# Comal County Environmental Health

### **Permit of Authorization to Construct an On-Site Sewage Facility Permit Valid For One Year From Date Issued**

Permit Number: 118797  
Issued This Date: 07/24/2025  
This permit is hereby given to: Robert and Hannah Savage

2345 ROCKY RIDGE LOOP  
CANYON LAKE, TX 78133

1 OF 3 - PROP. #3- 32'R  
SPRINKLER (K RAIN PRO PLUS MODEL 11003 - RCW).  
MIN. COVERAGE AREA = 5,313 SF  
ACTUAL COVERAGE AREA = 5,606 SF

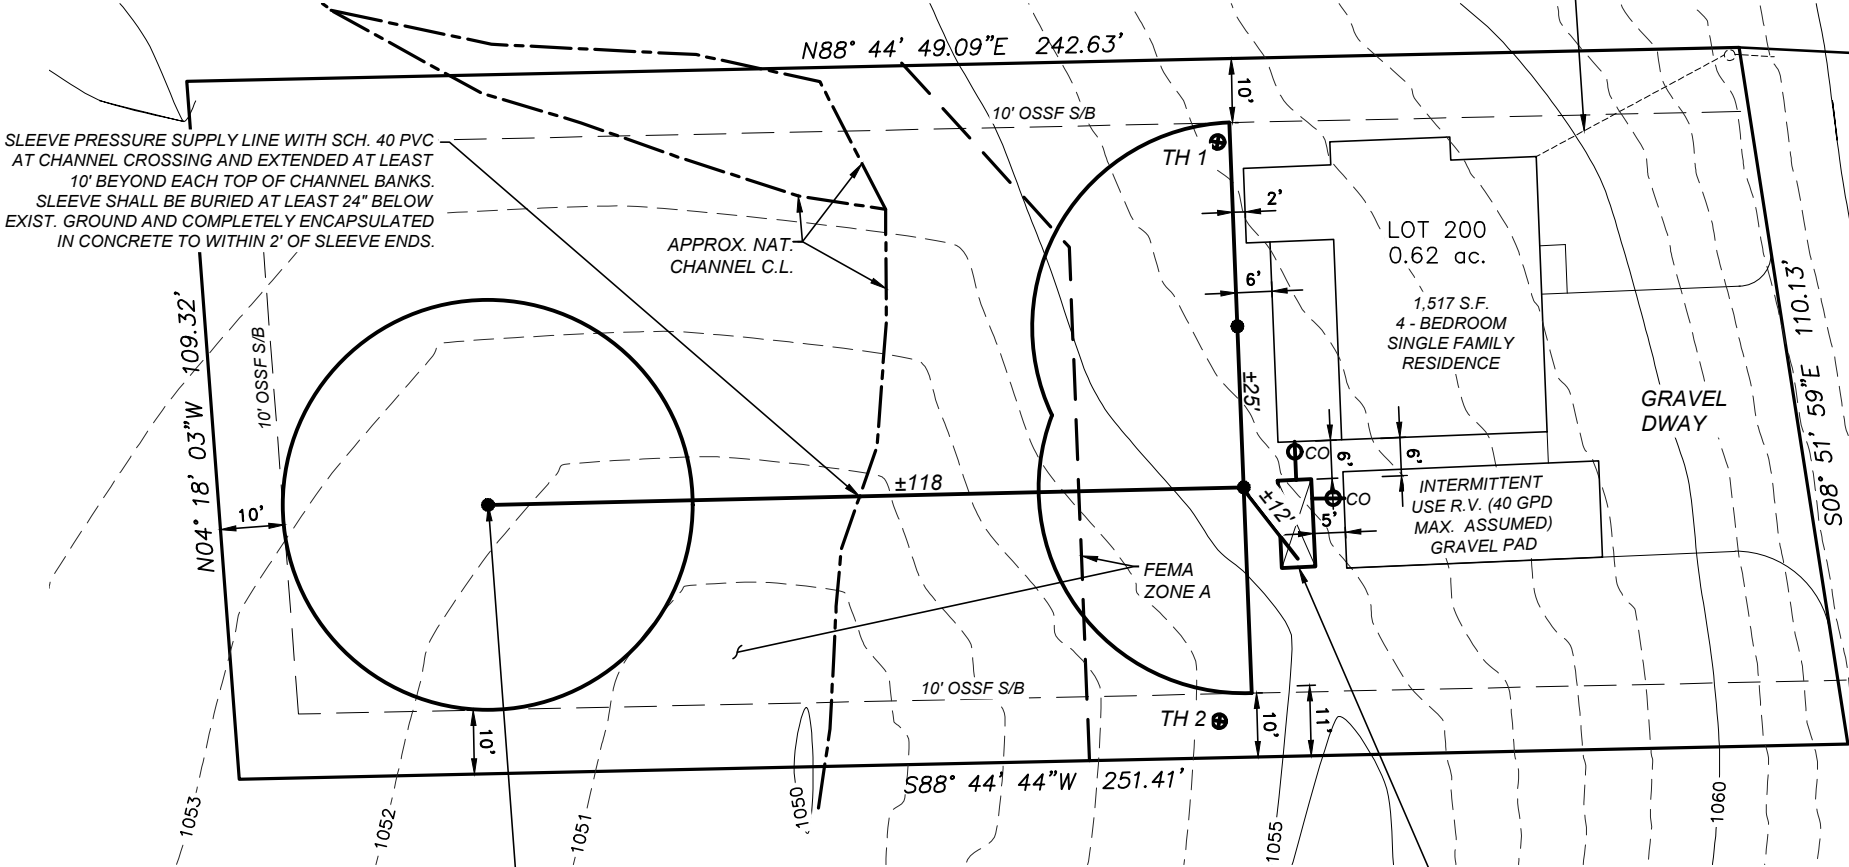
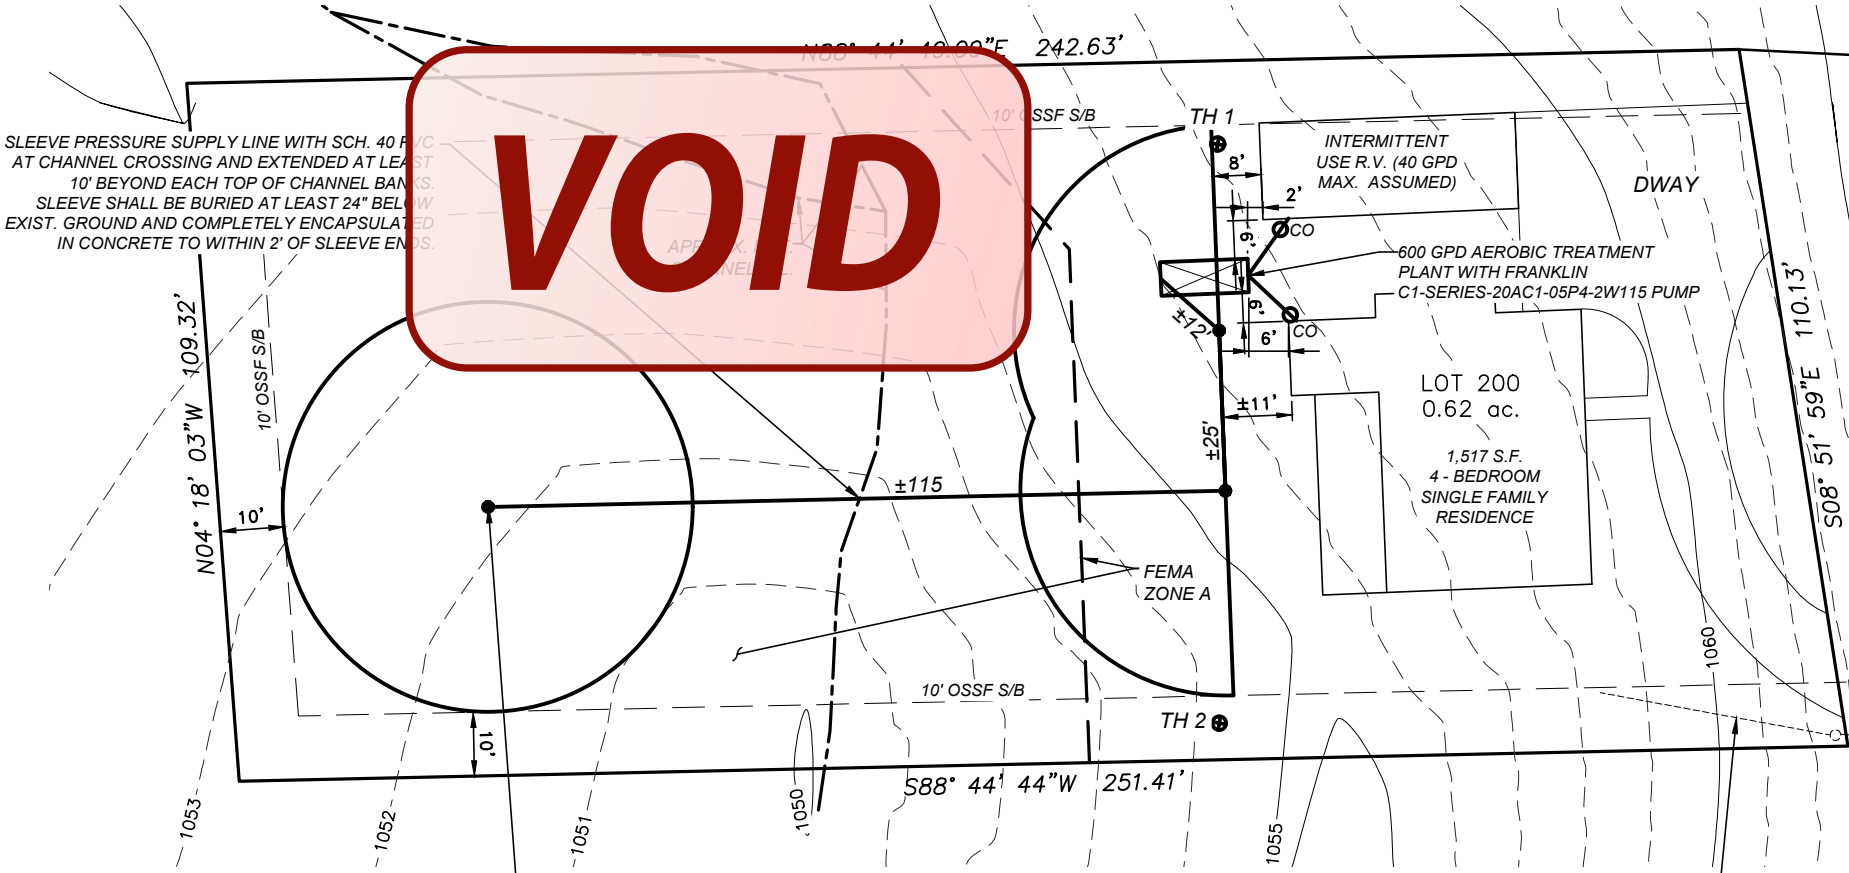
Revise actual coverage area sq footage on design and re submit.

1. Maintenance contract changed to license to operate from license to construct.
2. Update ATU model on site eval to match other forms.
3. Actual Sq Ft does not match on design from system description page.
4. Add intermittent use from RV to application.

2. ATU is not mentioned anywhere on the Site Evaluation Form but I did change the ATU specification on the calculation sheet;
3. I added the actual disposal area to the min. already noted on Application page #2 with my initials to the revision;
4. I added "+ intermittent Use RV" to Application page #1 and with my initials next to the revision.
